Access Compliance Report

Public Rights-of-Way

(Curb Ramps)

Intersection ID: 50597	Main Street: DOWNY_BIRCH_RD	Cross Street: GRAY_WILLOW_RD	Location: NE
ADA ID: 1276F9A40BF5	Ramp Type: Perp	Initial Pass/Fail: Fail	Overall Compliance: No
Severity Score: 1.25			
Codes/Mitigation Info/Possible Solution		Field Measurements/Component Compliance

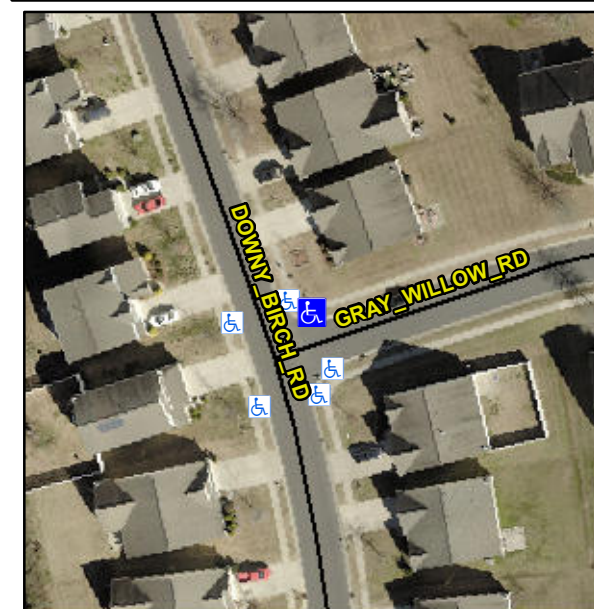
Not Found, R304.5.3

Compliance	Description	Data	Compliance	Description	Data
N/A	Ramp Length (in)	45.5	Yes	Ramp Slope (%)	6.9
Yes	Ramp Width (in)	48.0	No	Ramp XSlope (%)	2.4
N/A	Flare Type LT	N/A	N/A	Flare Type RT	N/A
N/A	Flare Slope LT (%)	N/A	N/A	Flare Slope RT (%)	N/A
N/A	Flare Traversable LT?	N/A	N/A	Flare Traversable RT?	N/A
N/A	Landing Length (in)	N/A	N/A	DWS Provided?	N/A
N/A	Landing Width (in)	N/A	N/A	DWS Contrast?	N/A
N/A	Landing Slope (%)	N/A	N/A	DWS Length (in)	N/A
N/A	Landing X Slope (%)	N/A	N/A	DWS Full Width?	N/A
N/A	Landing Curb? (Y/N)	N/A	N/A	DWS Offset (in)	N/A
N/A	Shared Landing?	N/A			
N/A	Gutter Ponding?	N/A	N/A	Gutter Slope (%)	N/A
N/A	Gutter Lip Ht (in)	N/A	N/A	Gutter X Slope (%)	N/A
N/A	Painted X Walk1?	No	N/A	Painted X Walk2?	N/A
	X Walk 1 Direction	To S		X Walk 2 Direction	N/A
N/A	X Walk 1 Width (in)	N/A	N/A	X Walk 2 Width (in)	N/A
	X Walk 1 Slope (%)	0.9		X Walk 2 Slope (%)	N/A
	X Walk 1 X Slope (%)	2.9		X Walk 2 X Slope (%)	N/A

N/A	Ramp inside XWalk1?	N/A	N/A	Ramp inside XWalk2?	N/A
	Road Slope (%)	N/A	N/A	Clear Space?	N/A
	Road X Slope (%)	N/A	N/A	Clear Space to XWalk (in)	N/A
N/A	Any Obstructions?	N/A	N/A	Storm Grate/Utility Hazard?	N/A
	Obstruction Type			Storm Grate/Utility Type	
		N/A			N/A
			Yes	Surface Condition? (G/P)	Good

Remove & Replace Entire Ramp.
